ADDENDUM #2 – APRIL 2, 2025

RE: CITY OF COQUILLE URA
N. Adams Street Improvements Phase 1: Underground Improvements
Project #23.81

FROM: HGE ARCHITECTS, Inc.
333 South 4th Street
Coos Bay, Oregon 97420
541-269-1166

SANITARY SEWER - STA 40+00 - 44+59

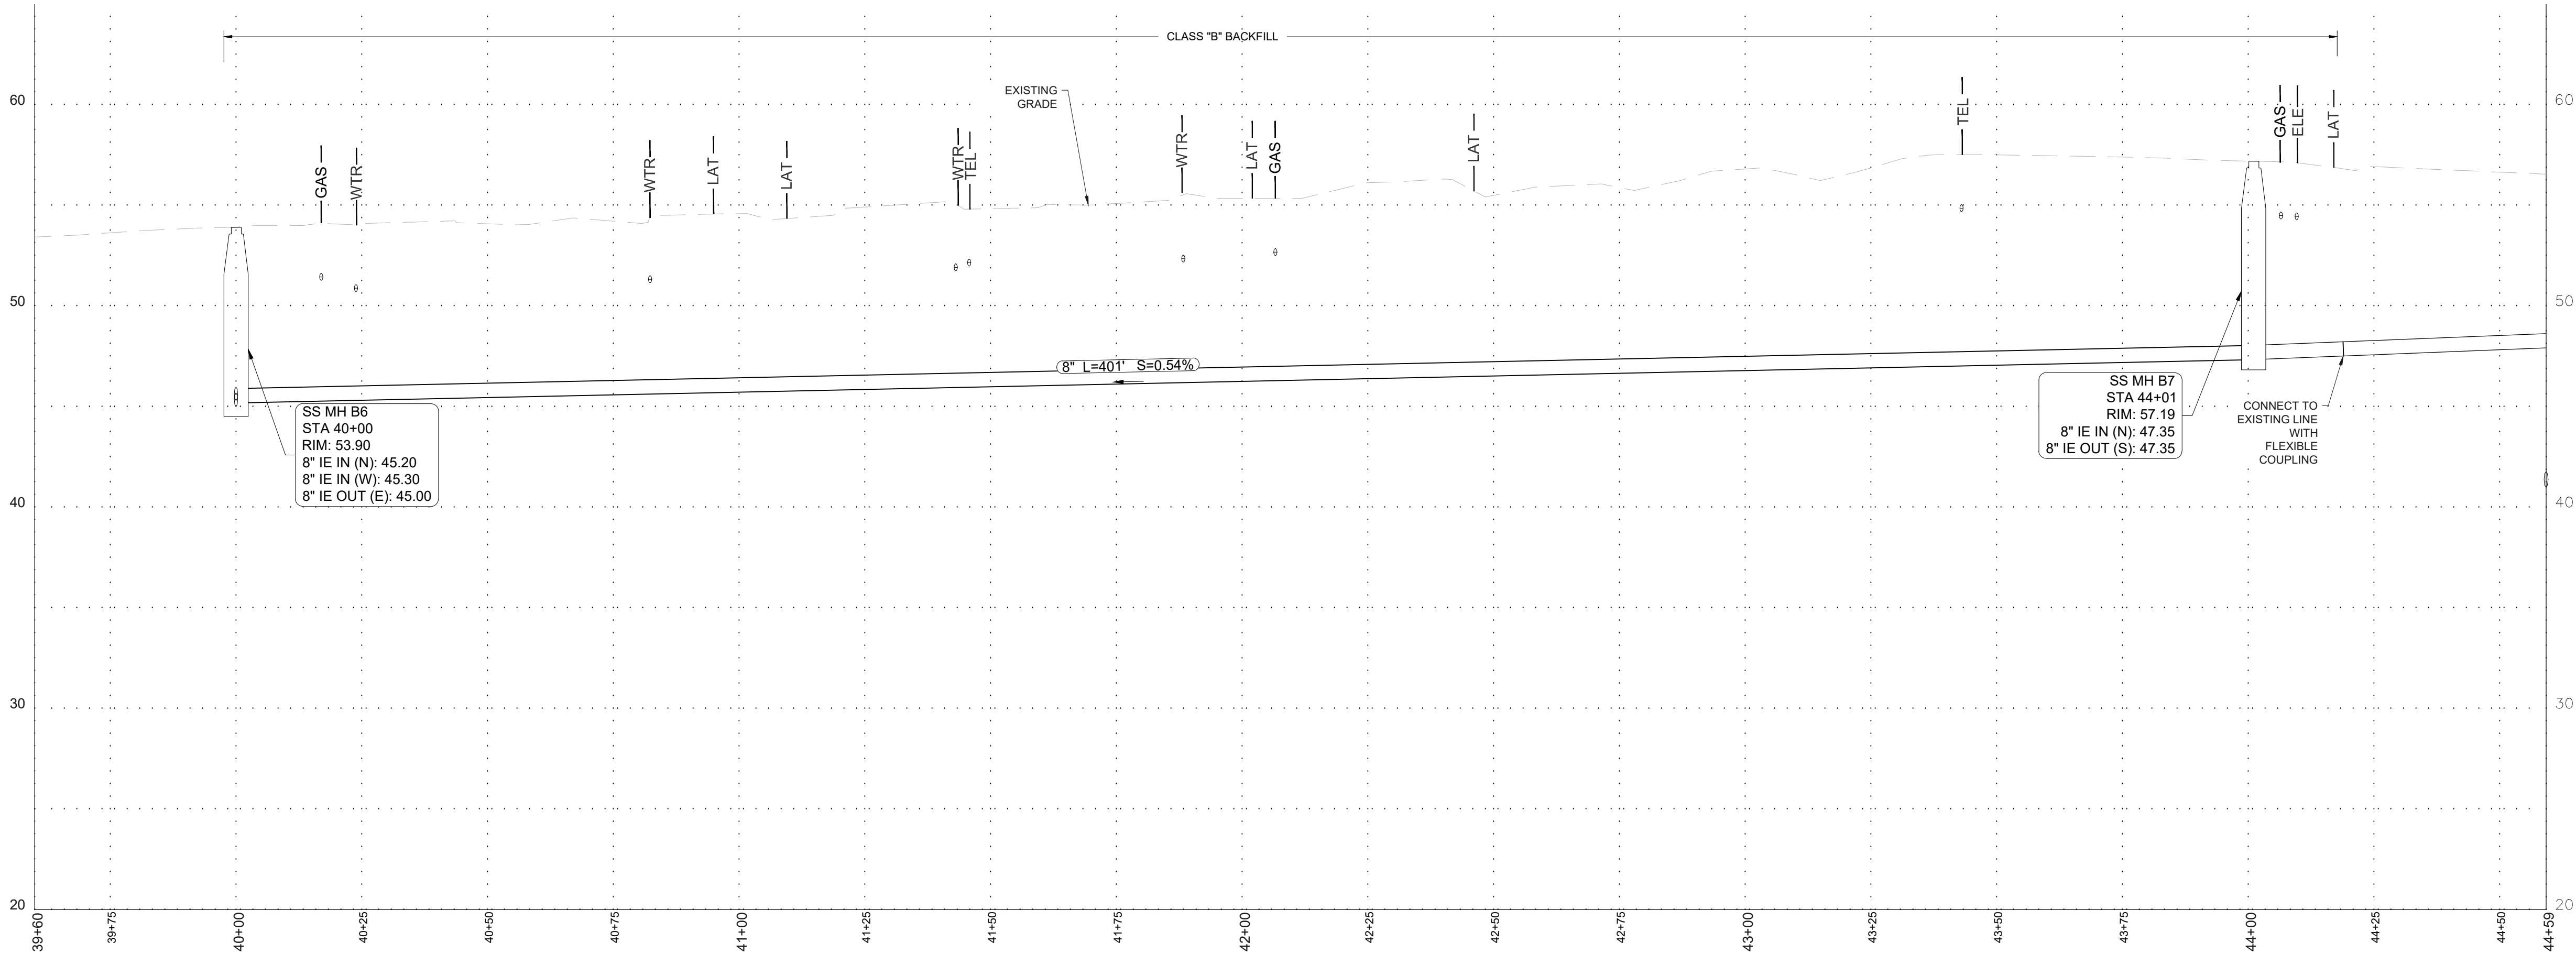
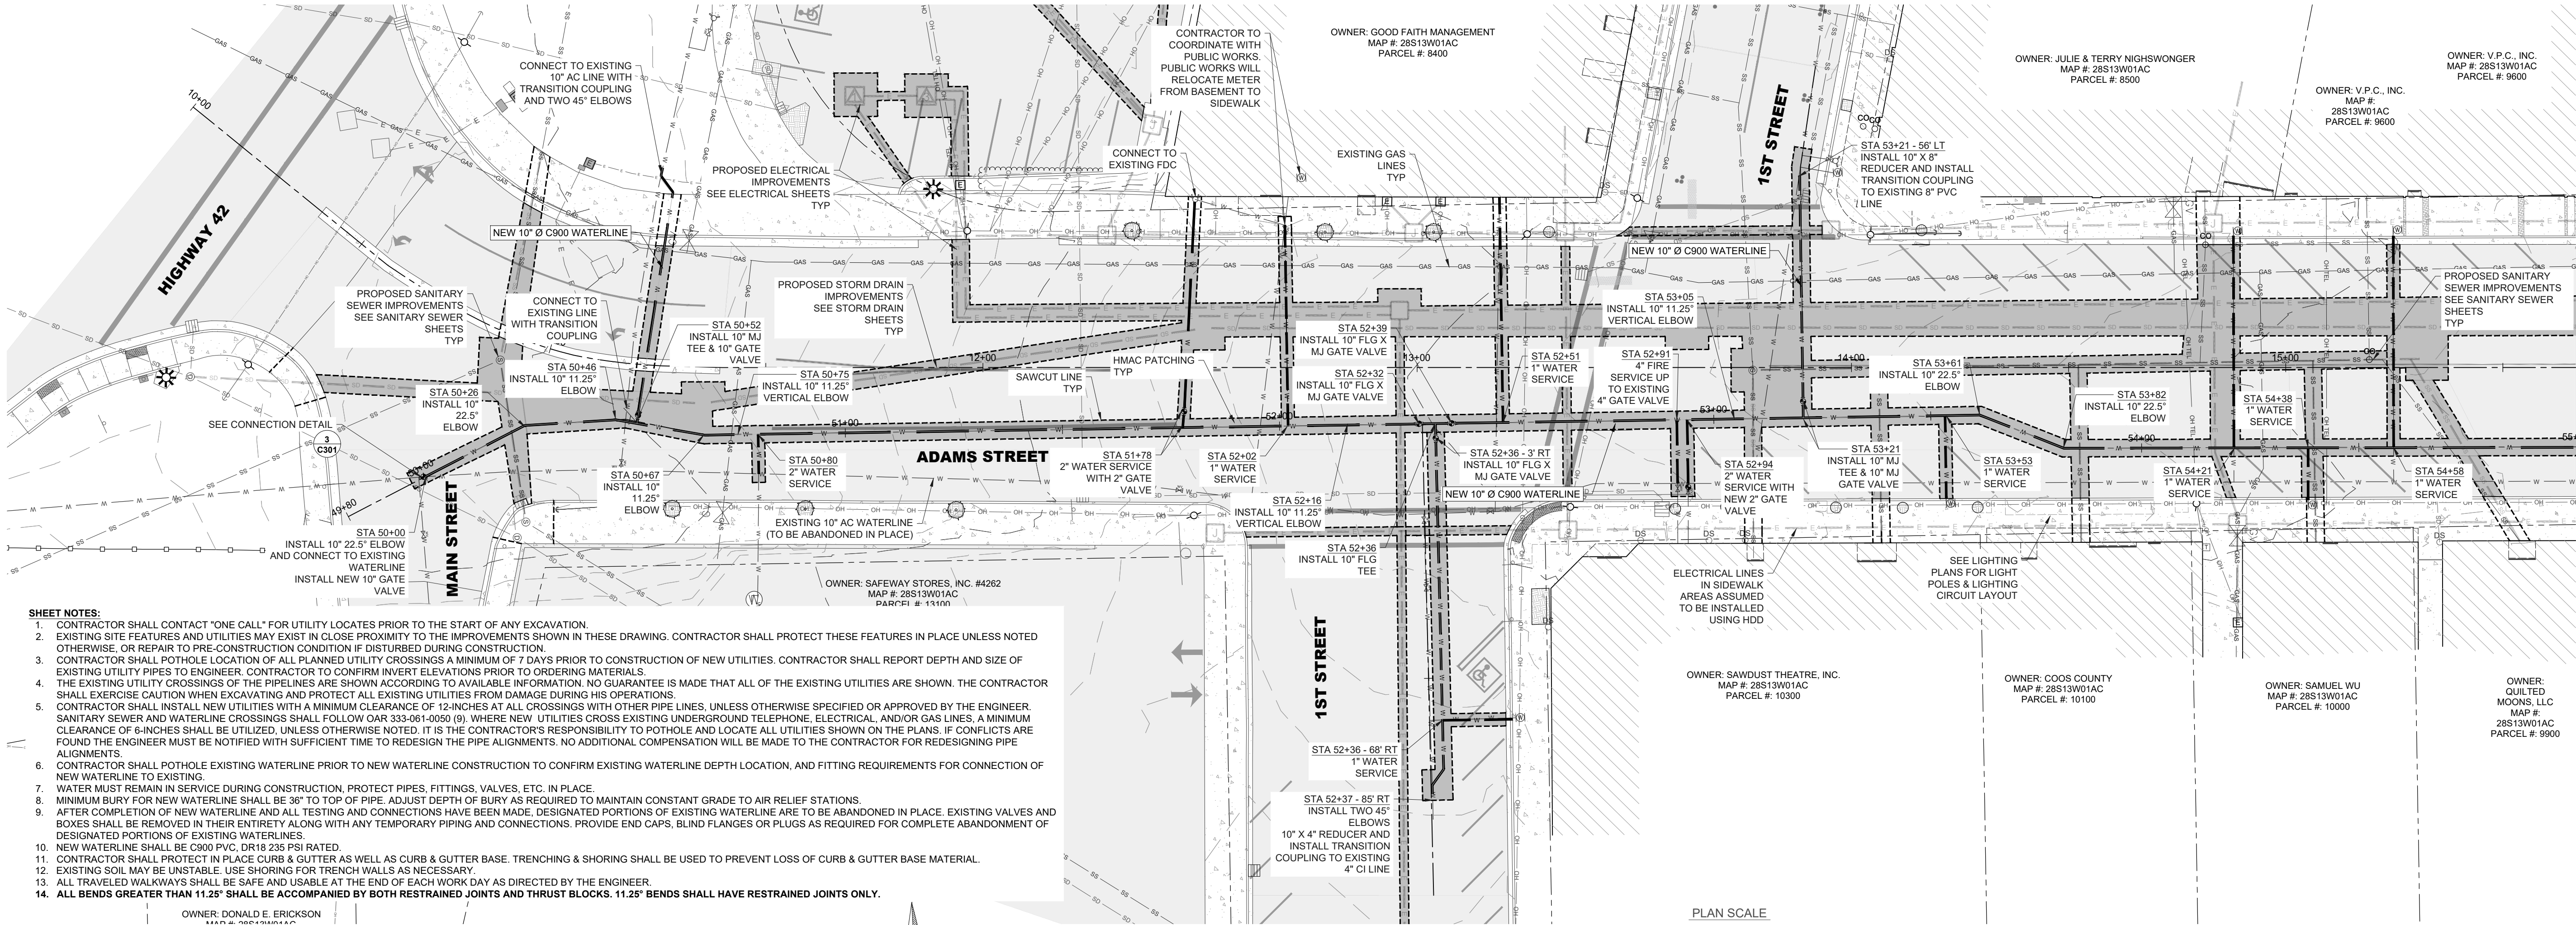
- ii. Deleted a note pointing to nothing
 - iii. Corrected lateral at STA 31+10 or so to 6" from 4"
2. **Sheet C201 Sanitary Sewer – STA 40+00 – 44+59:** REPLACE sheet with attached revised sheet.

- a. **Revision Summary:**
 - i. Added lateral at 40+95, corrected 42+09 to 6" from 4"
 - ii. show point of connection for lateral at FCCU.
3. **Sheet C300 Waterline Improvements – STA 50+00 – 55+00:** REPLACE sheet with attached revised sheet.
